Agenda
for
115th PCC Meeting

EASTERN REGIONAL POWER COMMITTEE

AGENDA FOR 115th PROTECTION COORDINATION SUB-COMMITTEE MEETING TO BE HELD ON 20.06.2022 AT 10:30 HOURS

DR of 220 kV Budhipadar-Lapanga-1 (Budhipadar)

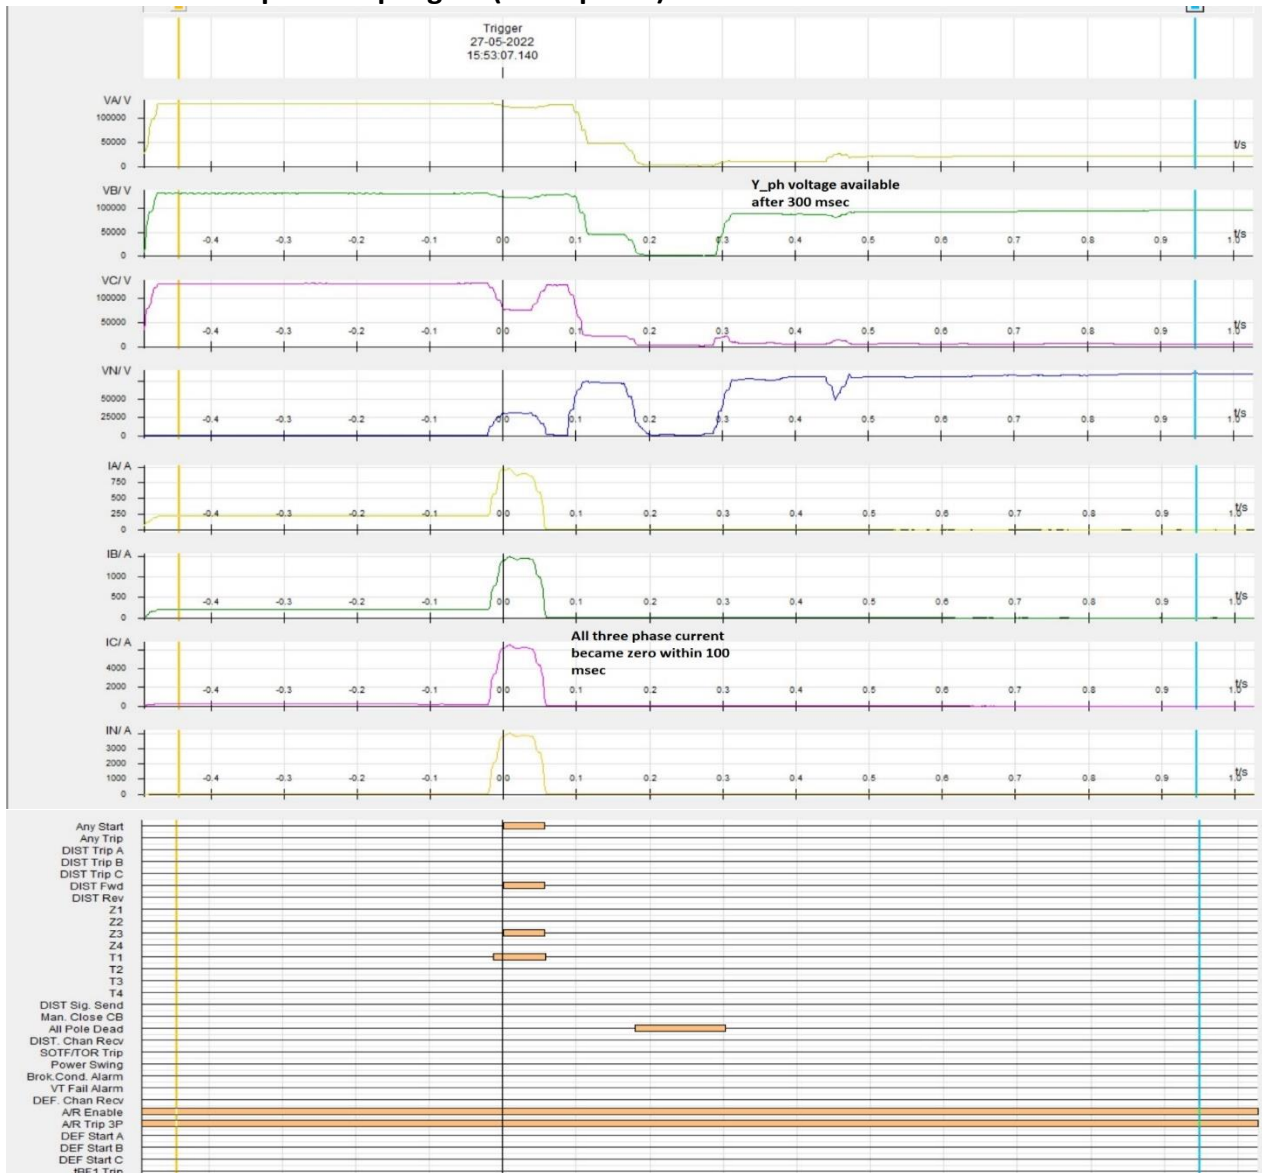
- 220 kV Budhipadar-Lapanga-1 tripped immediately in Zone-1 from Budhipadar although it sensed the fault in zone-3 , T1 became high. **Time setting to be checked by OPTCL for Budhipadar end.**, line tripped in Zone-4 from Lapanga after 300 msec.

DR of 220 KV Budhipadar-Lapanga-2 (Budhipadar)

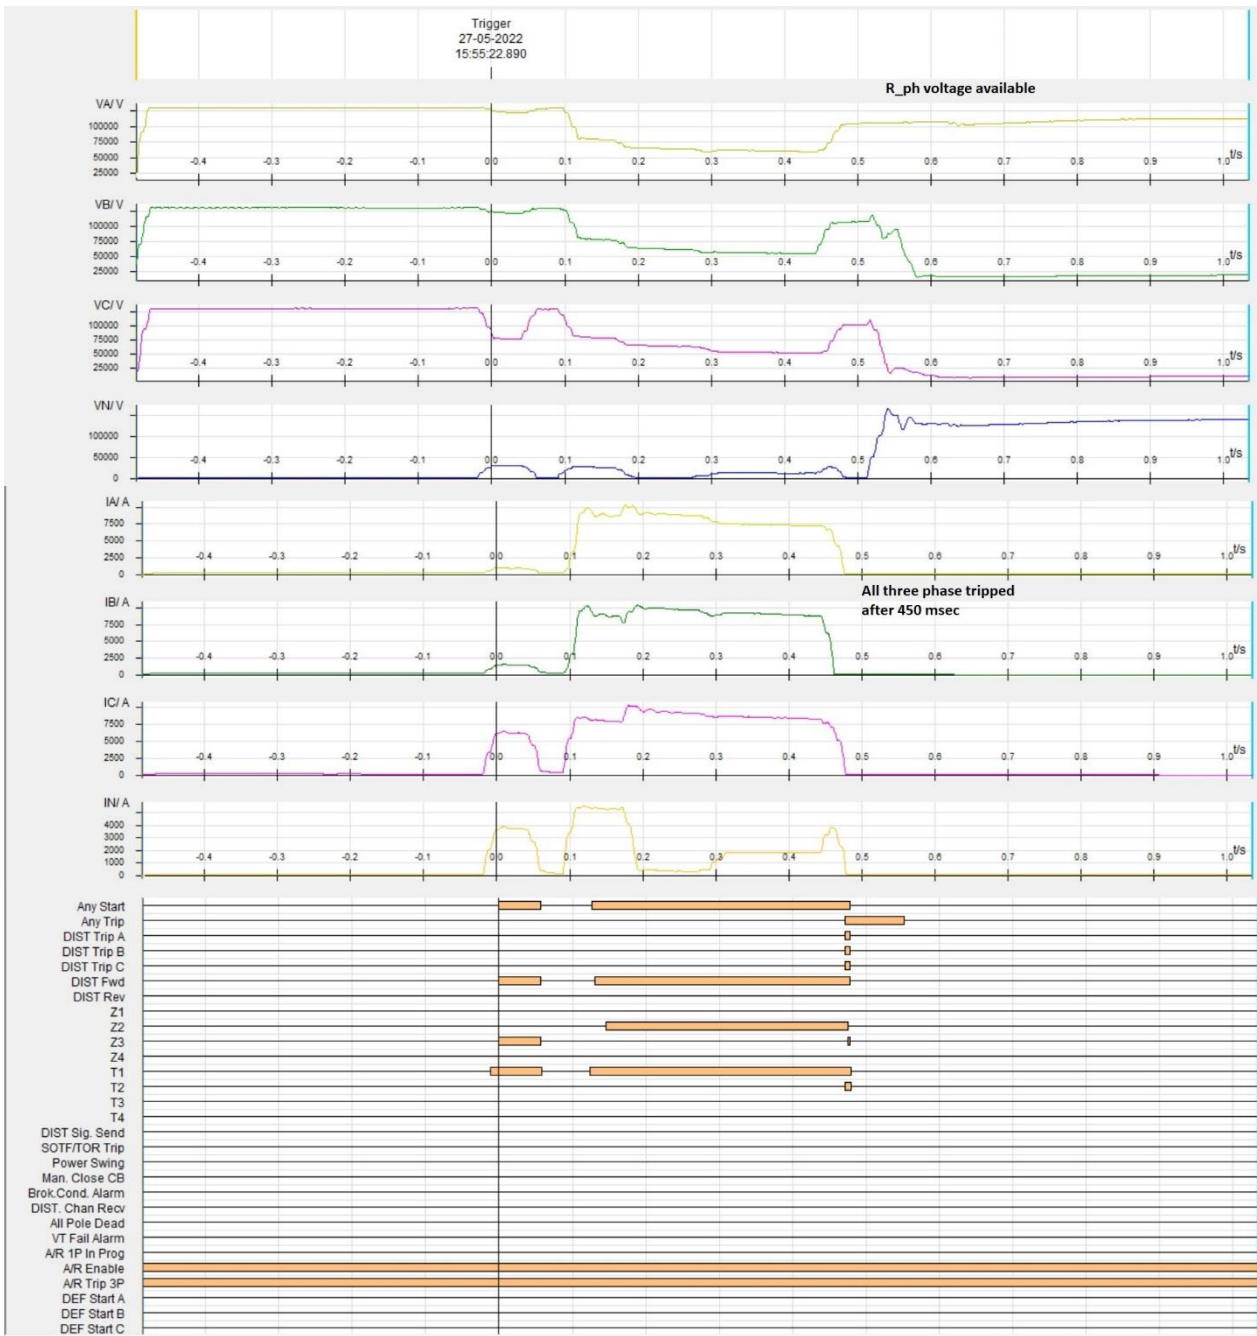
- 220 kV Budhipadar-Lapanga-2 tripped after 450 msec in Zone-2 initially it was picked in zone-3 but got reset as current reduced then again with increase in current picked in z-2 from Budhipadar, line tripped in Zone-4 from Lapanga after 300 msec.

DR of 400/220 kV ICT-1 at Lapanga (HV side)

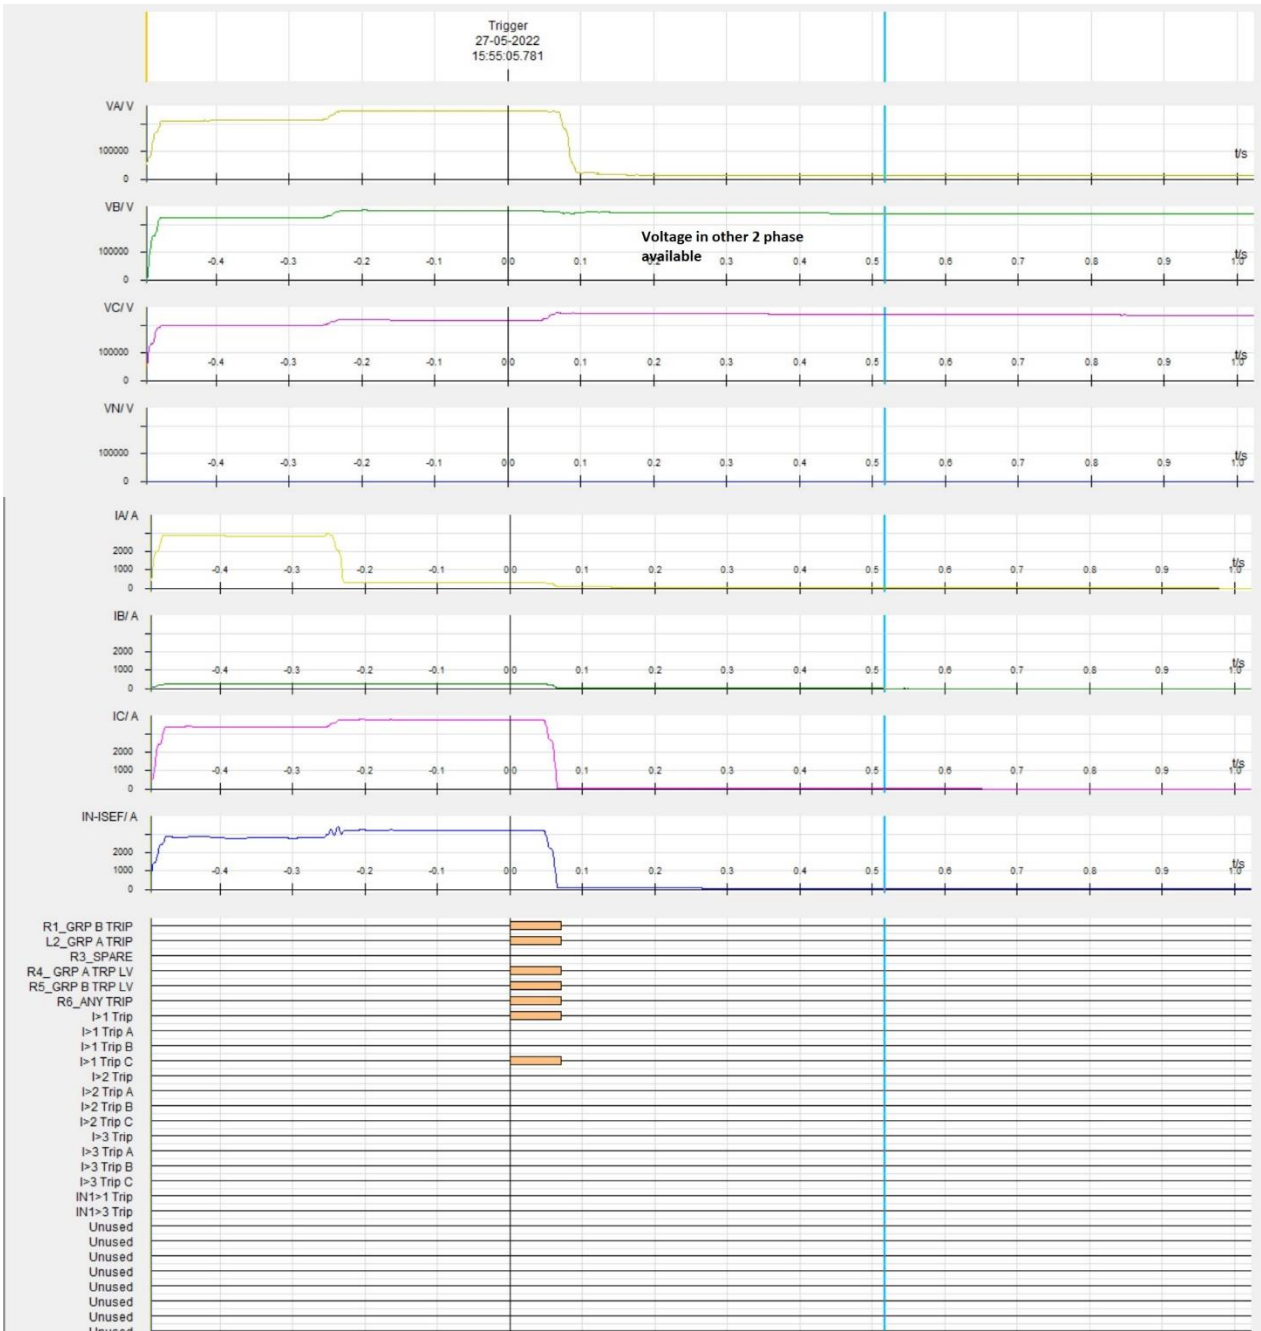
- 400/220 kV ICT-1 tripped from HV side on Directional O/c after 1.64 seconds and fault was isolated from the system. Directional O/c setting to be co-ordinated. At this point all other sources were out and only source was ICT-1 so CT saturation may take place needs to be checked so **ICT backup O/C to be tested for healthiness by OPTCL.**

DR of 400/220 kV ICT-2 (LV side)

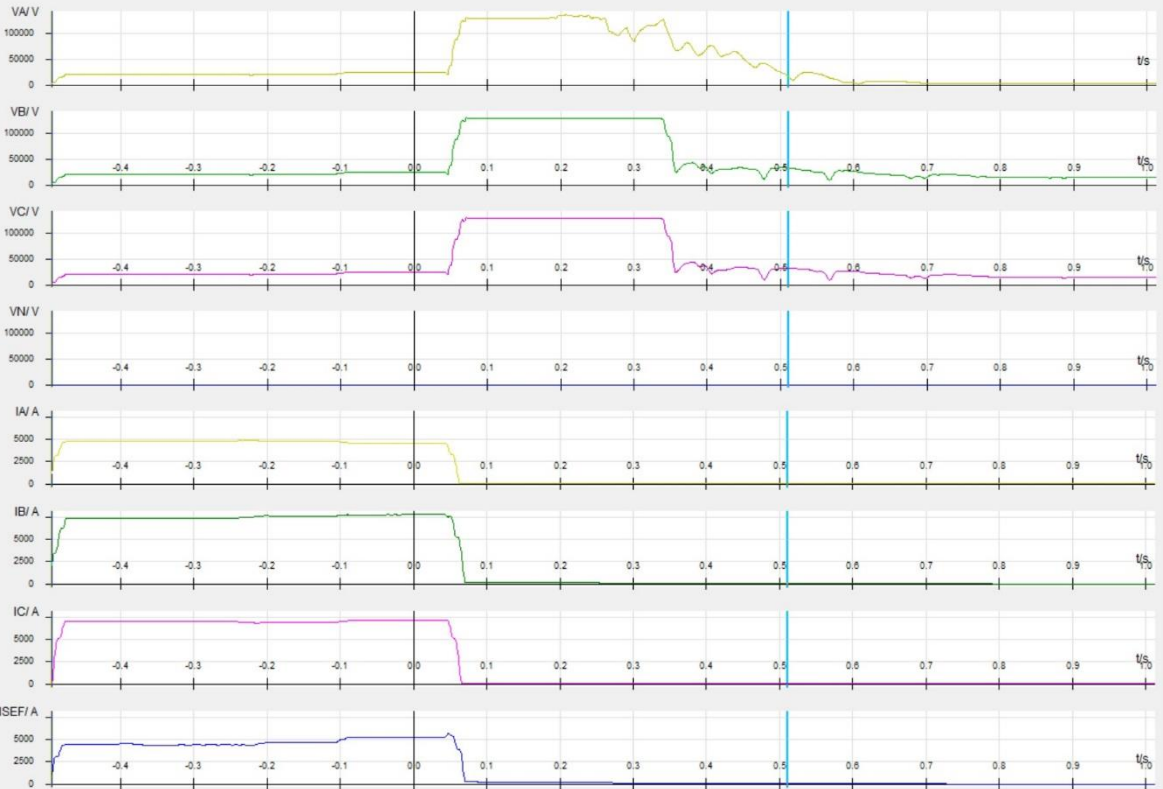
- 400/220 kV ICT-2 tripped on high-set O/c within 80 msec from LV side and sent intertrip command to HV side. As per DR, current in Y_ph and B_ph was above 7 kA in LV side. However, this current is higher than the current value in HV side after adjusting transformation ration. **ICT backup O/C to be tested for healthiness by OPTCL.**

Fig 4: Ckt-1 B phase Line current at Rourkella end

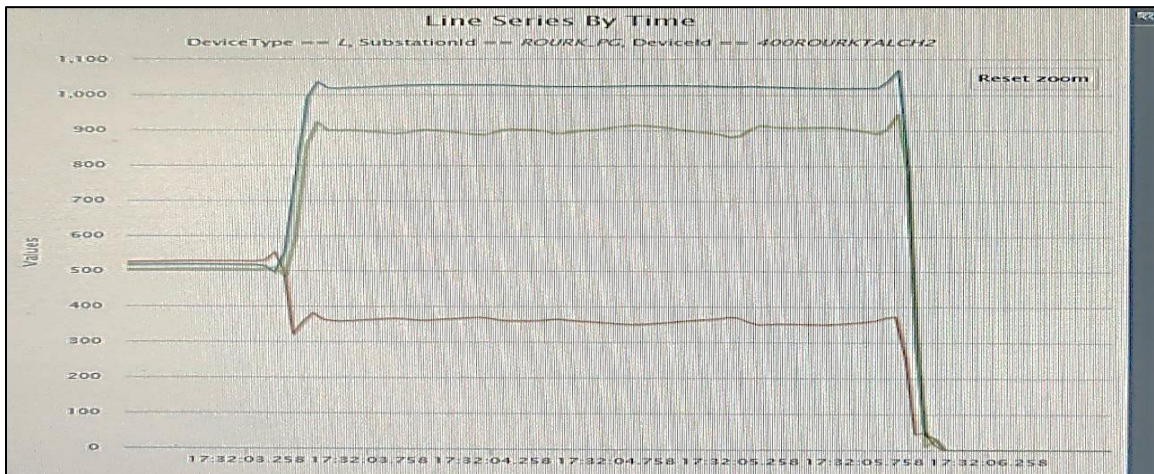
- During the same time ckt 2 also tripped due to the arc fault in vicinity with ckt-1 after 300 ms from Talcher end and DT was sent to Rourkela. **Ntpc Talcher to intimate yet What protection operated at Talcher end ?**

Fig 7: Ckt-1 Line current at Rourkella end

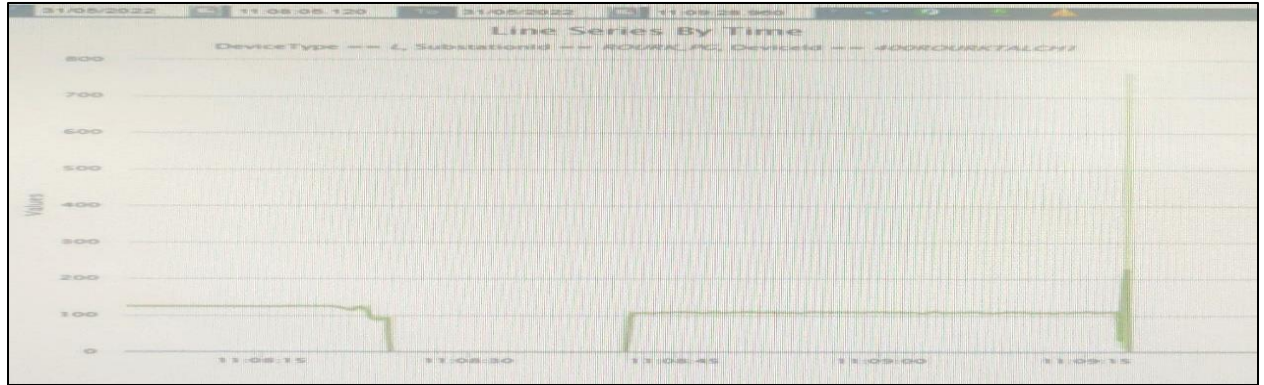
5. Still after opening of ckt-2 , B phase voltage was persisting in ckt -1, so at Rourkela they tried to open the isolator, so it was almost online opening where at one end reactor was connected which created arcing and fault. **Even though the possibility of B phase voltage from Ckt-2 was ruled out why line isolator opening at Rourkela end done ? PG-ER-3 to reply?**

- Now with fault, Teed protection operated but as breaker was stuck it did not open hence LBB started and gave trip command but this also not operated properly ,and did not extended trip signal to other elements due to faulty o/p contacts, so all lines tripped from remote end in zone-2 and ICT tripped on backup impedance .
